## FENTON STREET BIKEWAYS MANDATORY REFERRALS

MR2022008 & MR2022011

Item No. 7

January 27, 2022

Figure 8: Fenton Street at MD 410 Intersection Reconstruction Project (north is to the right)

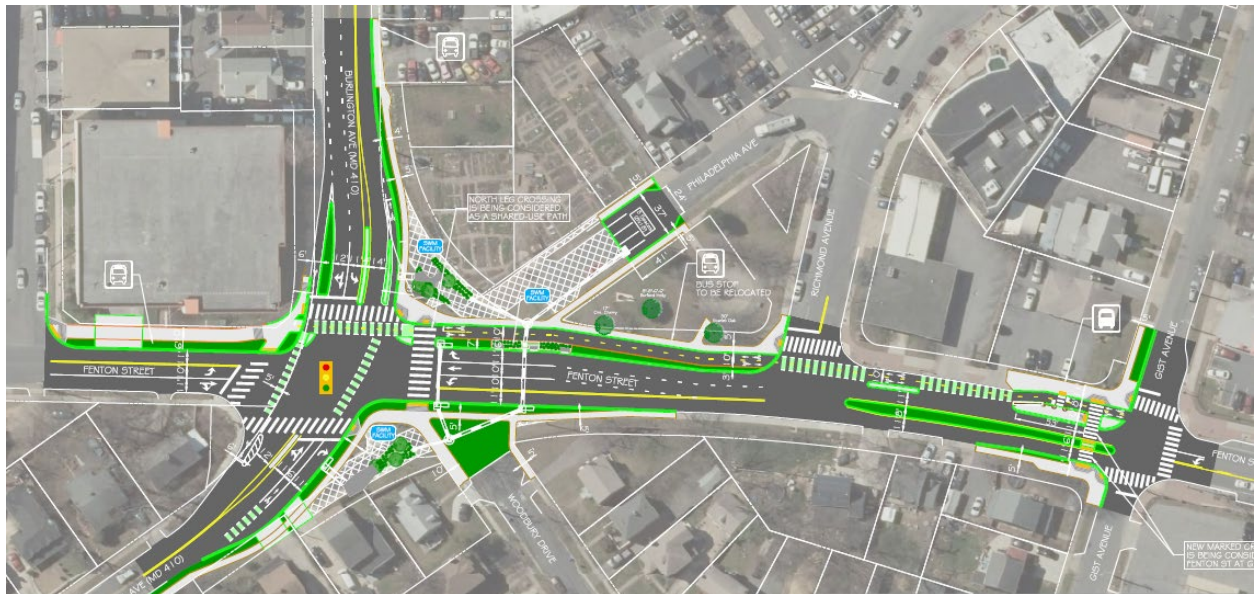
- The default **curb radius** is 15 feet to shorten the crossing and reduce the speed of turning traffic. The Fenton Street at MD 410 Intersection Reconstruction project proposes curb radii that are wider than 15 feet at three locations: 1) the southwest corner of the intersection of Fenton Street and Gist Avenue, 2) the southwest corner of the intersection of Fenton Street and Richmond Avenue, and 3) the northwest corner of the intersection of Fenton Street and King Street.

1. Per the Complete Street Design Guide, reduce the corner radius from 25 feet to 15 feet to shorten the crossing and reduce the speed of right turning traffic at three locations: 1) the southwest corner of the intersection of Fenton Street and Gist Avenue, 2) the southwest corner of the intersection of Fenton Street and Richmond Avenue, and 3) the northwest corner of the intersection of Fenton Street and King Street. If this dimension is too narrow for trucks to negotiate, explore the use of mountable truck aprons.
2. Install centerline hardening on King Street and Richmond Avenue to improve left-turning drivers' view of the crosswalk and to reduce the speed of left turning motor vehicles from Fenton Street to King Street.

Figure 12: Centerline hardening can improve the safety of pedestrians and bicyclists crossing the street by encouraging drivers to make left turns at slower speeds. (Source: Insurance Institute for Highway Safety)

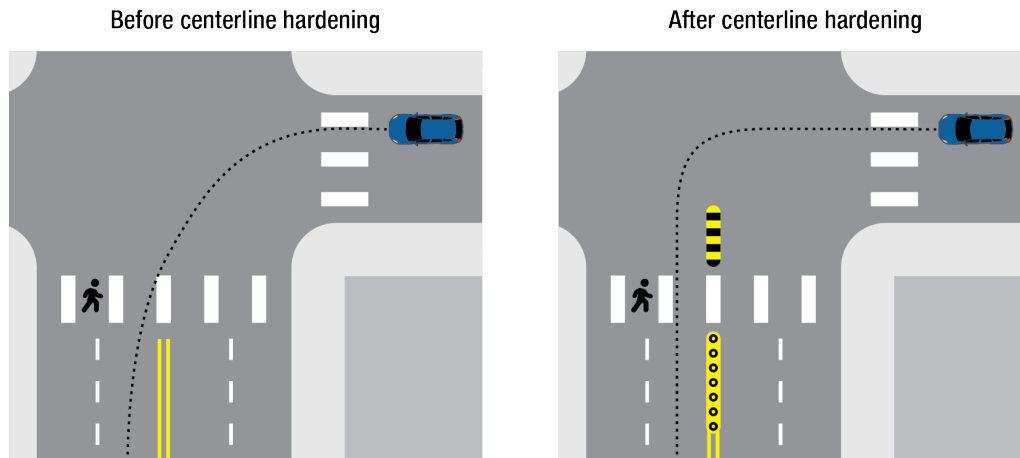
While the Fenton Street Bikeway project (see Section 7) proposes signalization with exclusive left turn phases to eliminate conflicts between left-turning motor vehicles and pedestrians and bicyclists crossing the street along the west side of Fenton Street, signals are not proposed at the intersections with King Street and Richmond Avenue. To reduce conflicts between left turning vehicles and pedestrians / bicyclists and to reduce the speed of left turning vehicles, the project could consider installing centerline hardening at the intersections with King Street and Richmond Avenue (Figure 12).

Figure 14. Proposed pavement beyond existing limits to be removed to avoid impacts to the 30-inch scarlet oak at the corner of Fenton Street and Richmond Avenue

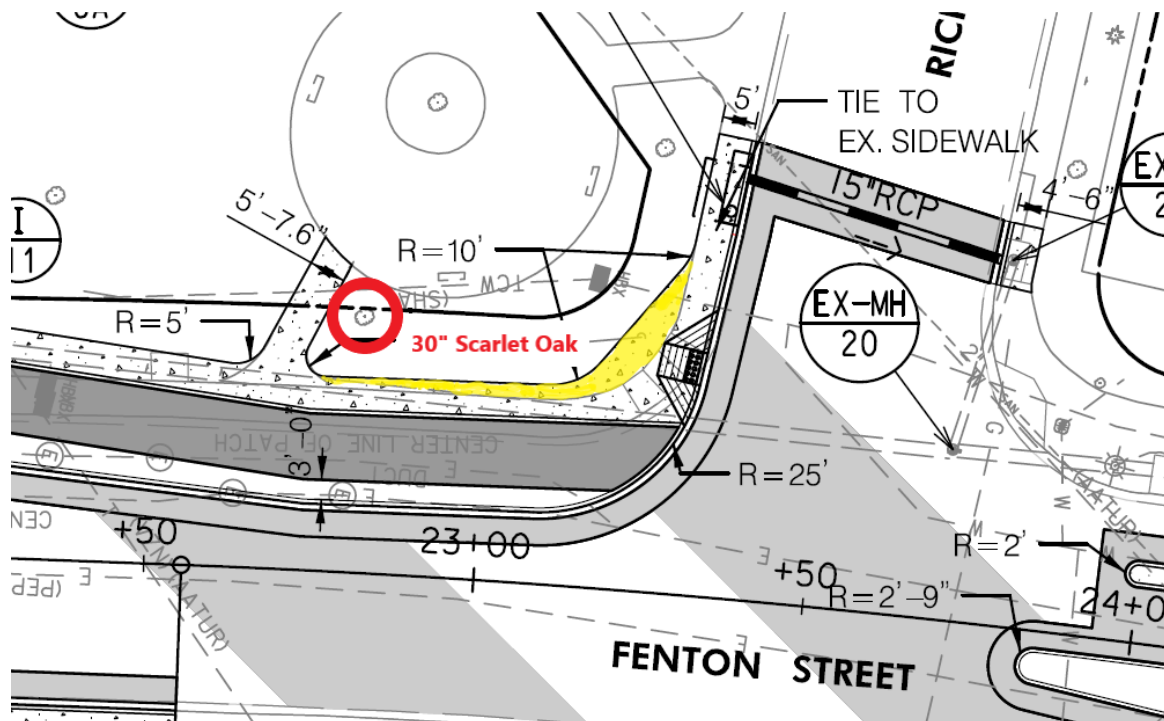
The current intersection improvement plan shows a relocation of the sidewalk along Fenton Street Urban Park within the critical root zones of two trees, a 30-inch scarlet oak and a 17-inch ornamental cherry (see Figure 14). Parks' analysis indicates that the 17-inch cherry will need to be removed as part of the project. As MCDOT has committed to saving the 30-inch scarlet oak, impacts should be minimized by limiting paving work to the existing pavement limits directly adjacent to the tree, including, where possible, at the corner of Fenton Street and Richmond Avenue (see Figure 15). Continued coordination through final design and construction will be required to increase the likelihood of tree survival.

4. Along Fenton Street Urban Park, remove the 17-inch ornamental cherry tree.
5. Along Fenton Street Urban Park, modify the project so that the sidewalk and bikeway do not extend past the existing limits of the sidewalk to avoid the critical root zone of the 30-inch scarlet oak including, where possible, at the corner of Richmond Avenue and Fenton Street. Narrow the bikeway from 10 feet to 8 feet and widen the street buffer from 1 foot to 3 feet.

Figure 20: The existing bus stop at the northwest corner of Colesville Road and Fenton Street

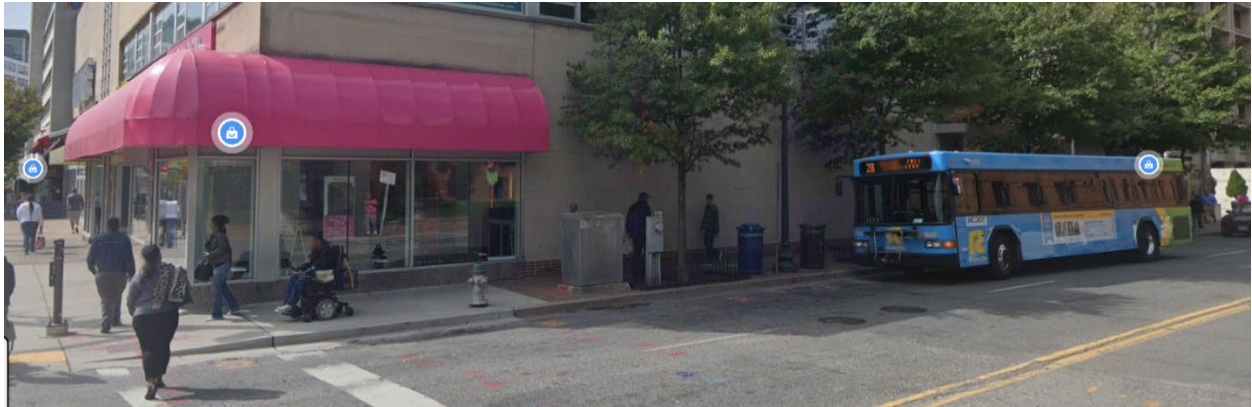
One challenge for the project is the bus stop at the northwest corner of the intersection of Fenton Street and Colesville Road, shown in Figure 20. Due to limited right-of-way, there is insufficient space to separate the bikeway from the transit waiting area.

Therefore, in this location MCDOT is proposing to provide a shared platform stop, which provides a bikeway at sidewalk level that can be traversed by transit passengers walking between the bus stop and the bus, as shown in Figure 21. While this approach is not ideal, there are likely to be fewer than 5 boardings and alightings on average per hour at this stop.<sup>2</sup>

Figure 23: Example of Curb Ramp Dimension at the Intersection of Fenton Street and Sligo Avenue

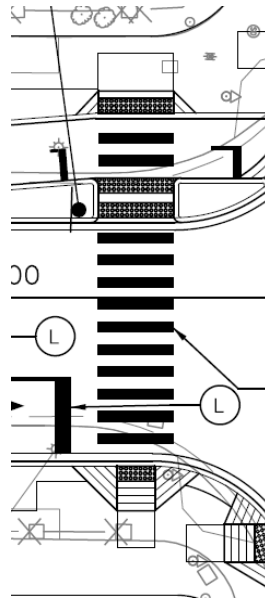
Curb ramps should match the width of the adjoining bikeway, sidewalks and crosswalks. As shown in Figure 23, the curb ramps on the west side of Fenton Street (top of the image) match the width of the crosswalk, but the curb ramps on the east side of Fenton Street (bottom of the image) do not.

1. Widen the ramps on the east side Fenton Street to match the crosswalk width.
2. Between Silver Spring Avenue and Thayer Avenue, explore ways to expand the buffer between the bikeway and on-street parking from 2 feet to 3 feet.
3. Per the Complete Street Design Guide, reduce the corner radius from 20 feet to 15 feet where feasible. If this dimension is too narrow for trucks to negotiate, explore the use of mountable truck aprons.

Figure 24: Intersection of Wayne Avenue and Fenton Street

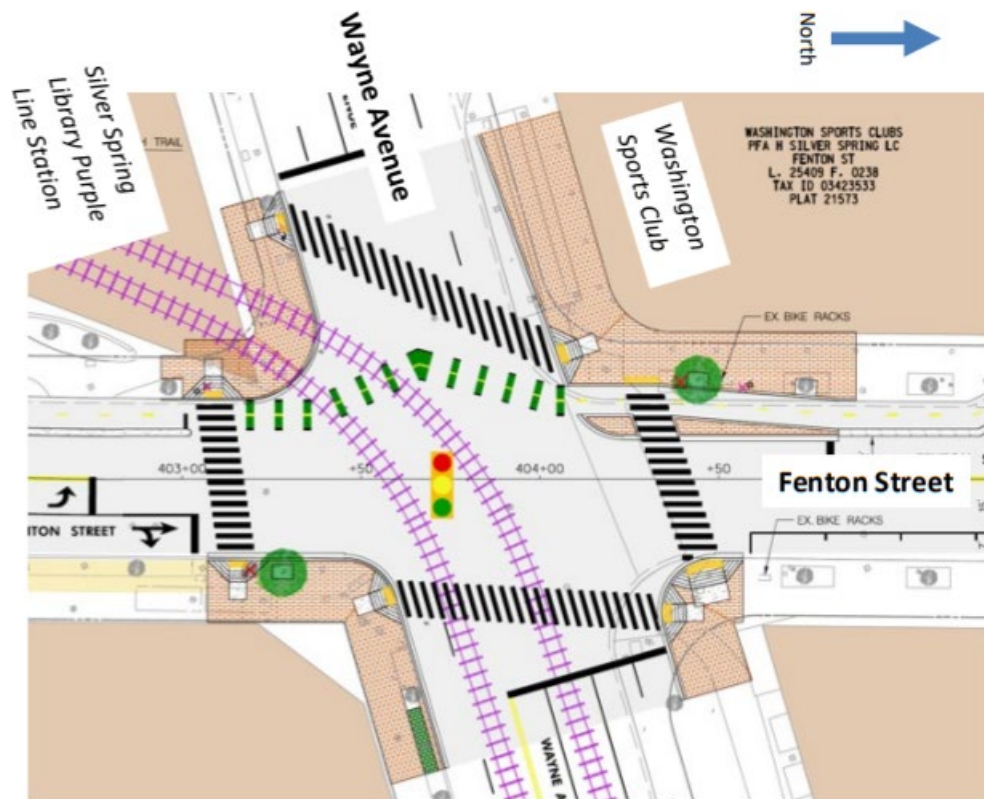
During the Planning Board’s review of MCDOT’s Fenton Street Study on January 21, 2021, staff brought up a concern about the orientation of the Purple Line tracks through the intersection of Wayne Avenue and Fenton Street, which creates challenges for bicyclists crossing the west leg of the intersection. As shown in Figure 24, the bike lane markings have a bend in them to encourage bicyclists to cross the Purple Line tracks at as close to a 90-degree angle as possible. This reduces the likelihood of a bicyclist crashing by getting a wheel caught in the trackbed. These markings encourage the safest riding behavior, but they are not likely to be followed. Most bicyclists will continue straight across the intersection. The Planning Board’s comments on study therefore included the following comment: “Coordinate with Montgomery Planning staff to undertake a design process to better separate pedestrians, bicyclists, motor vehicles and light rail vehicles at the Fenton Street/Wayne Avenue intersection.”

MCDOT staff met with Planning Department staff to review the intersection design and to discuss alternatives to improve the crossing. They indicated that the Purple Line project has committed to

installing flange fillers in the tracks to reduce the chances that bicycle wheels will get caught in the trackbed.
